TO: Mills City Council
FROM: Megan Nelms, AICP, City Planner
DATE: February 25, 2025
SUBJECT: Vision Beyond Borders – Development Plan

Case Number: 24.04 DEV

**Vision Beyond Borders
Commercial Development Plan**

DRAINAGE PLAN
VISION BEYOND BORDERS
MILLS, WY

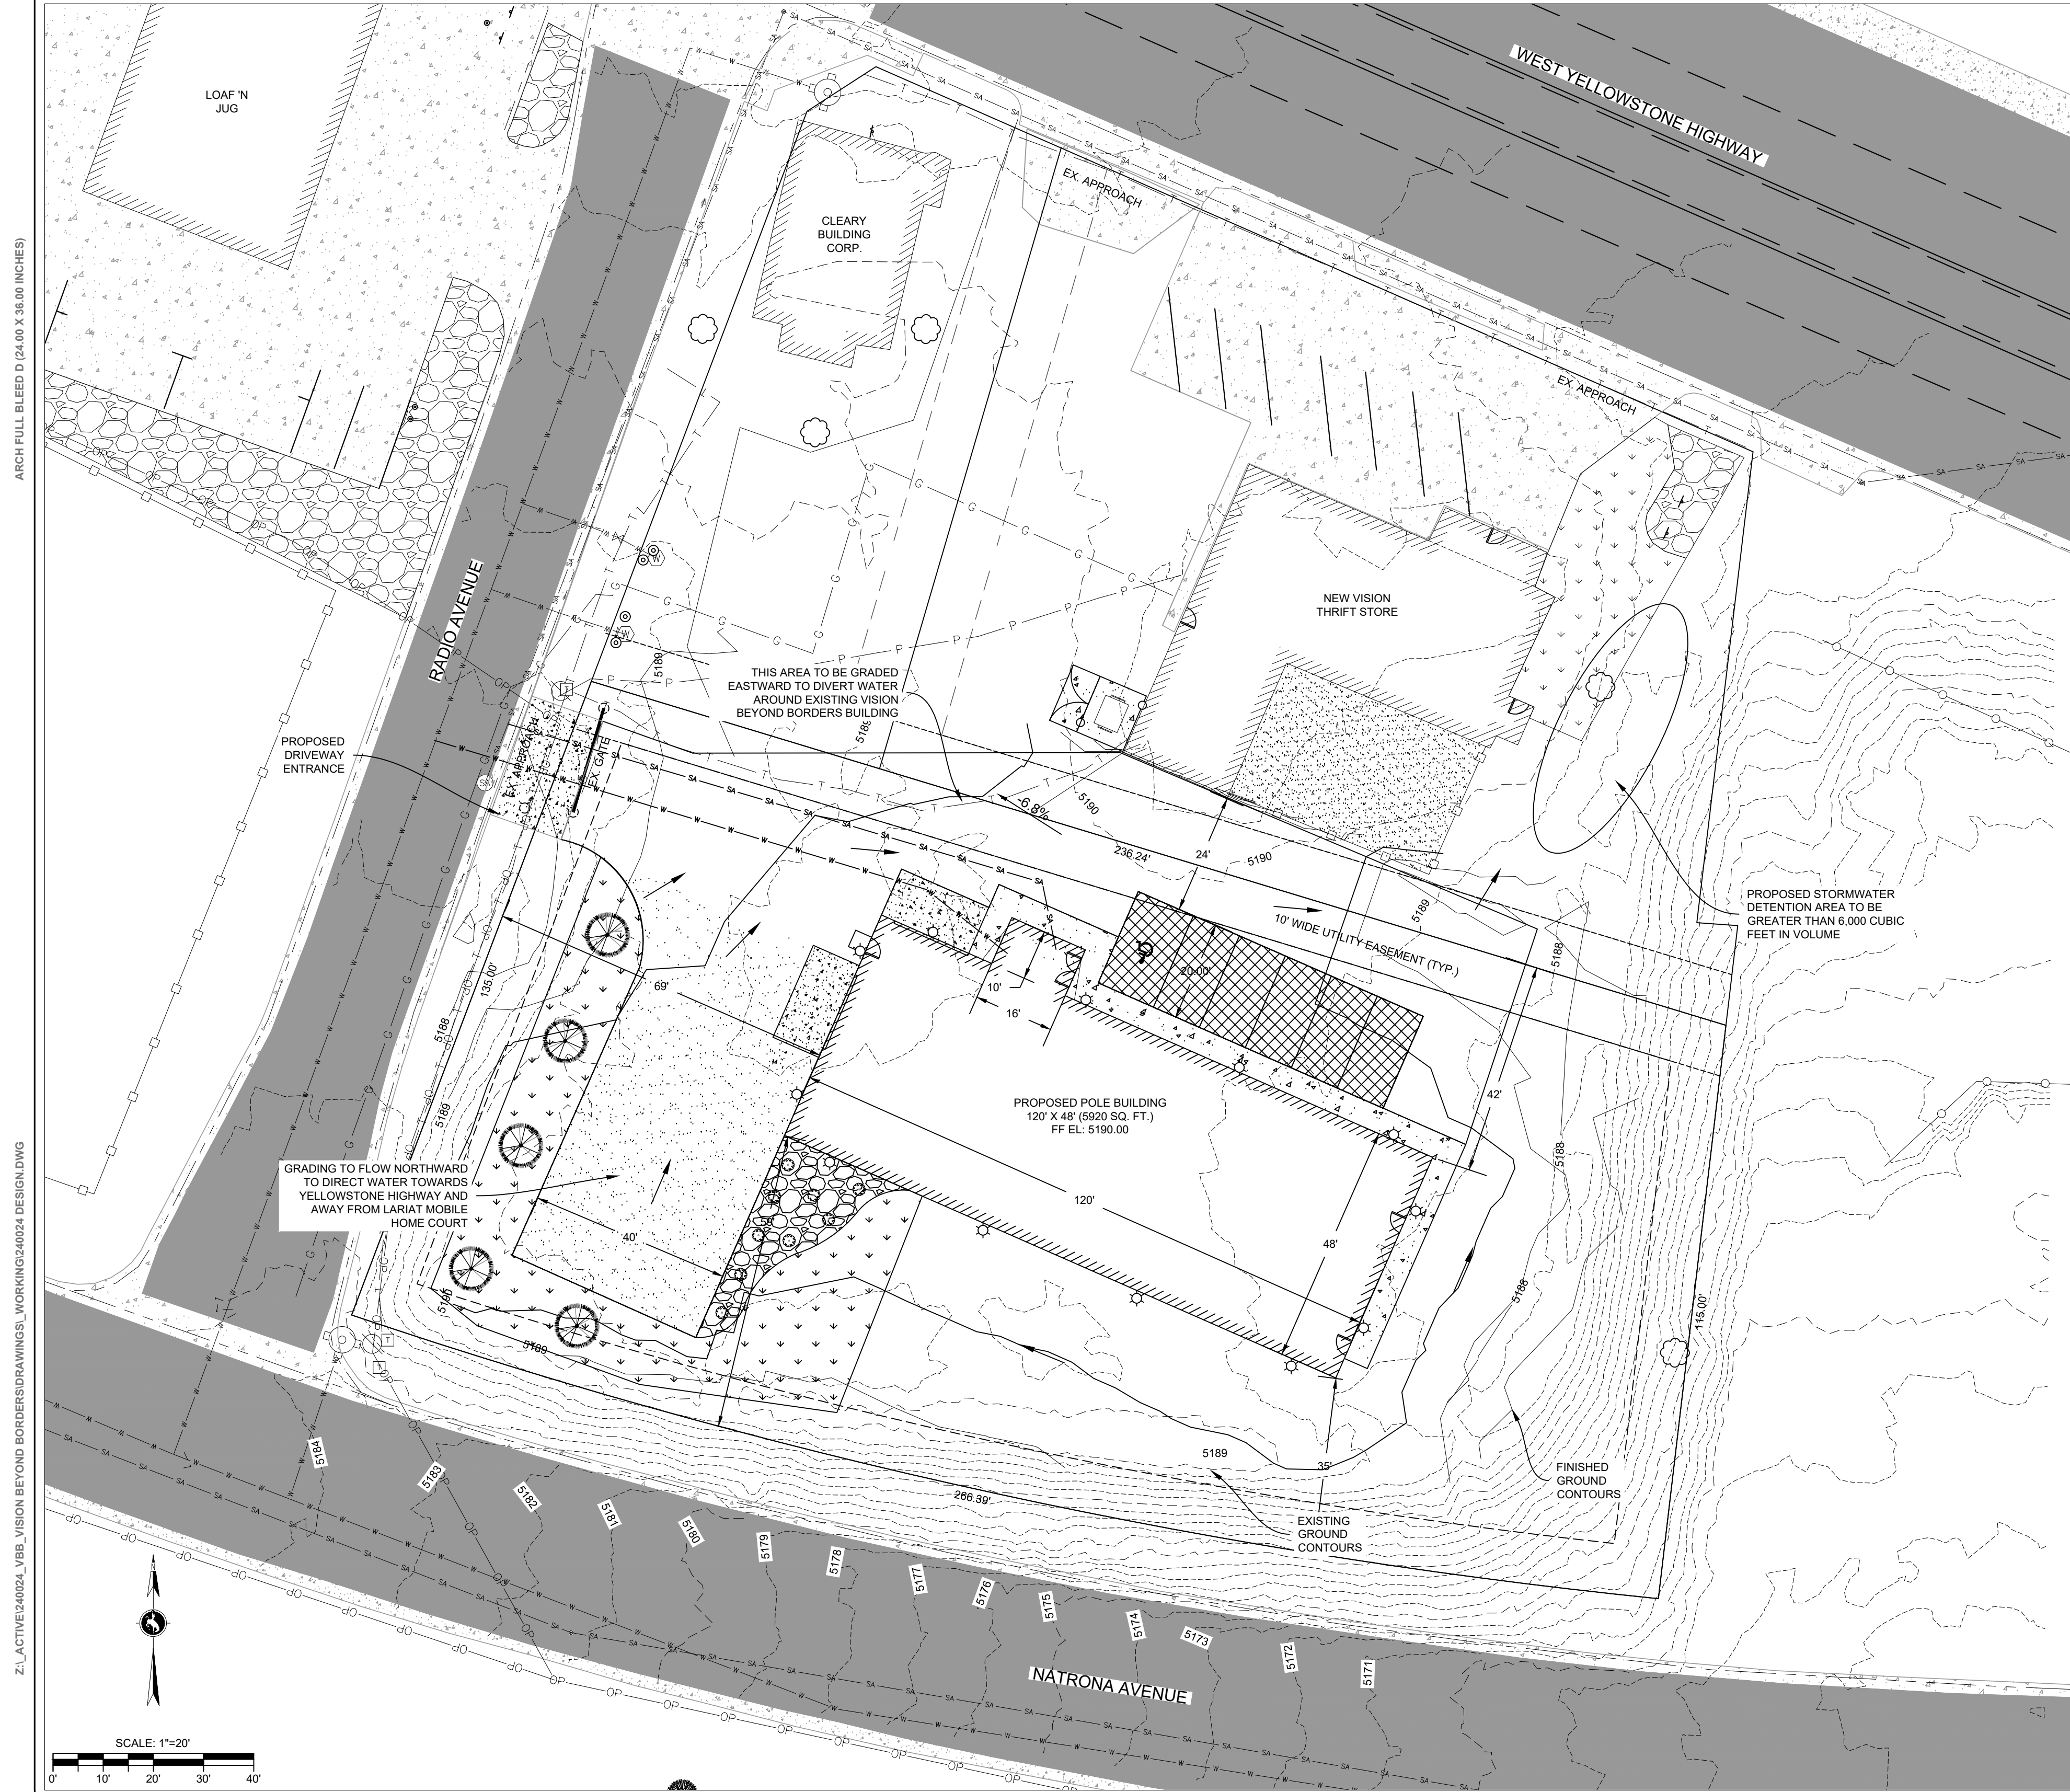
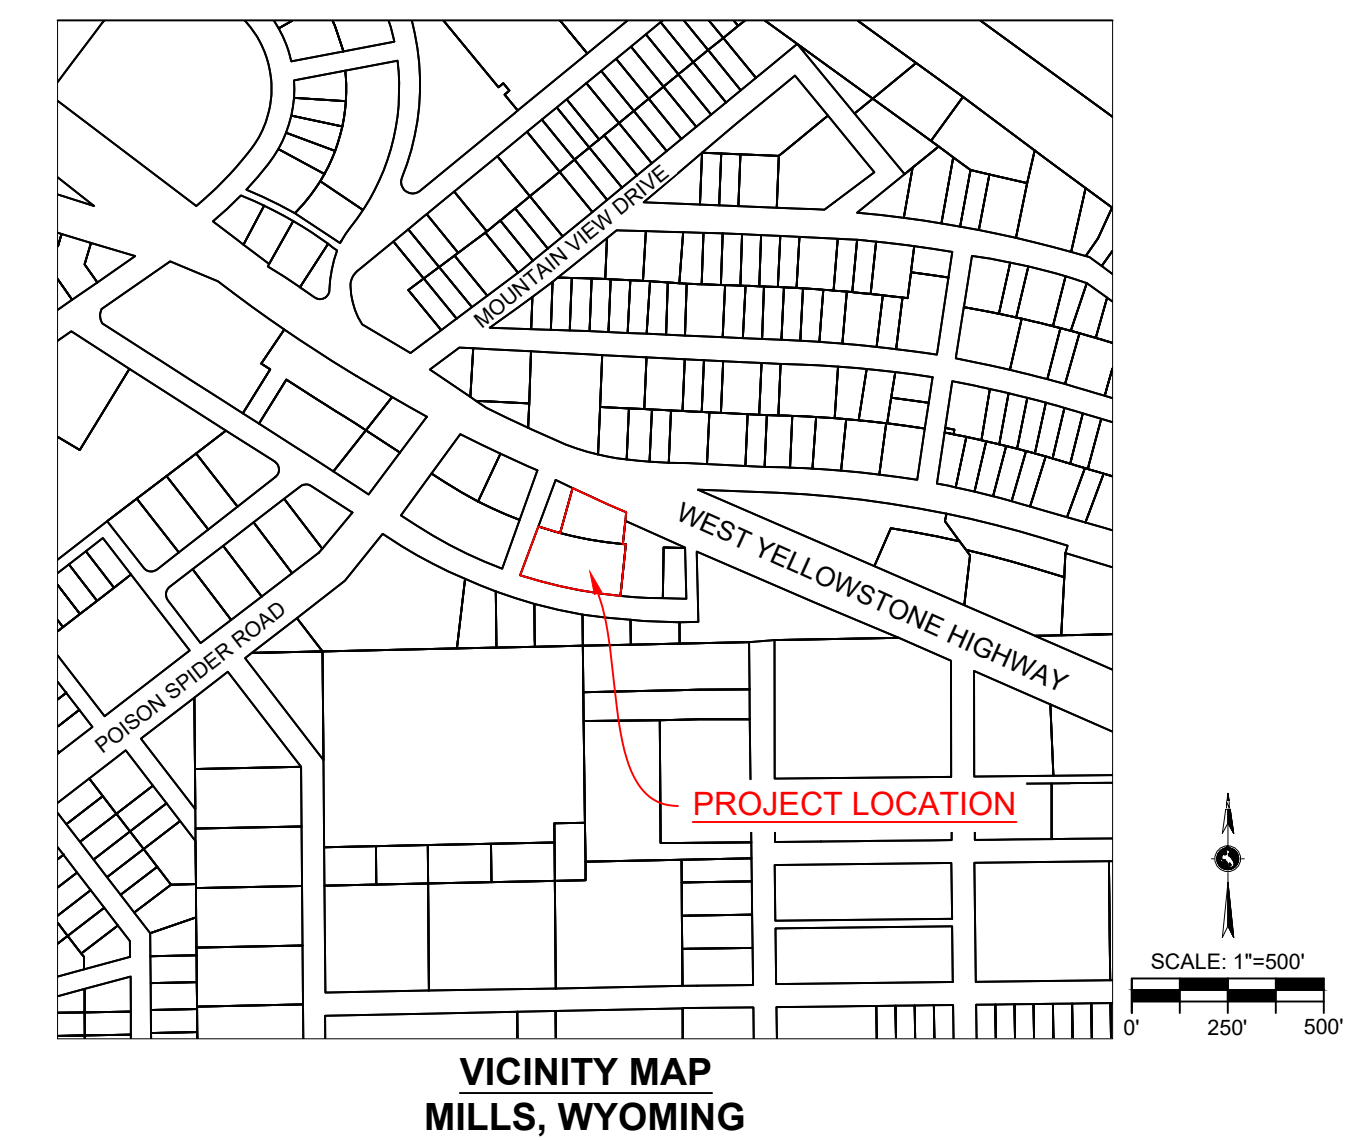
Chairman Gudger then asked if there were any questions from the commission. Vice Chairman Volzke questioned the updated drainage plan, saying it shows a small storm water detention area next to the thrift store, and he wants to confirm that a final drainage plan and design will be forthcoming. Megan confirmed that a final drainage plan would be required as part of the approval. Board Member Bryson commented there still wasn't a shared access easement shown for the access aisle between the two lots.

LANDSCAPE PLAN
VISION BEYOND BORDERS
MILLS, WY

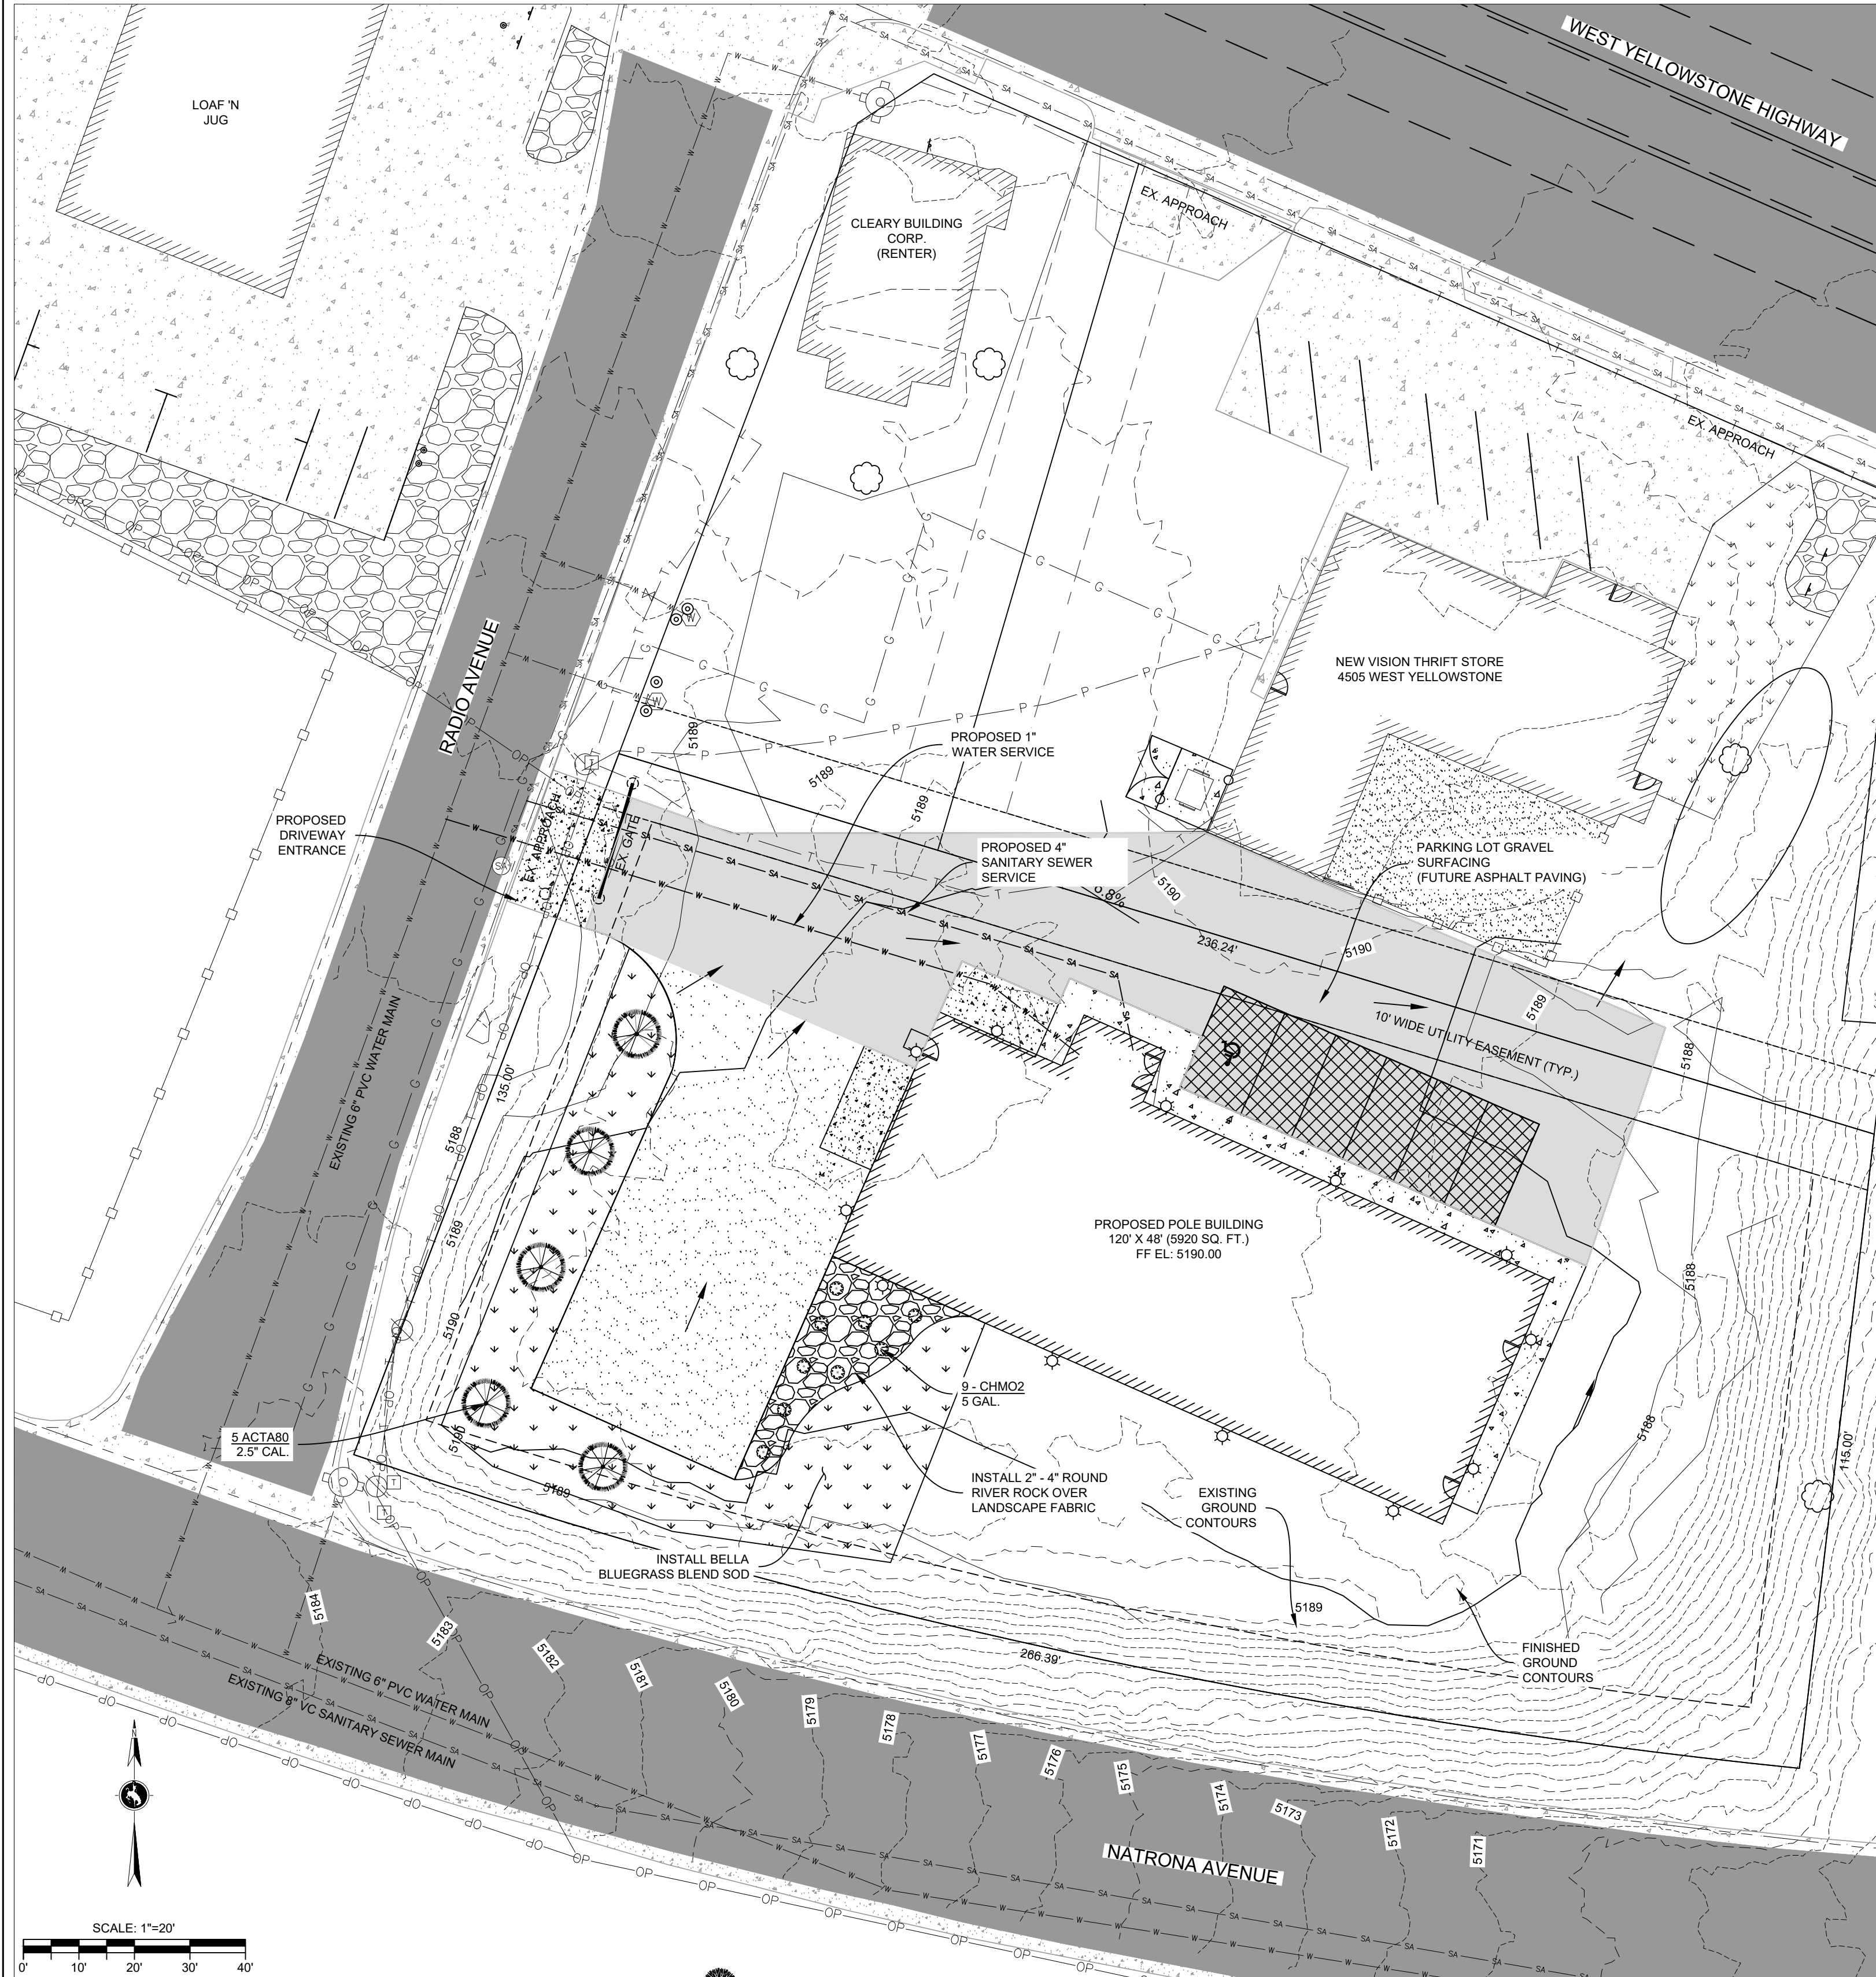
2. Section 40.40(4), a minimum of 10% of the site shall be landscaped. A conceptual landscaping plan was submitted with the previous application. An updated, detailed landscape plan has been submitted and appears to be in conformance with the LDRs.

Board Member Bryson also had comments regarding the landscaping plan, stating he would like to see the landscaping closer to Yellowstone Highway, be recognizing that the landscaping is required to be installed on the lot being developed.
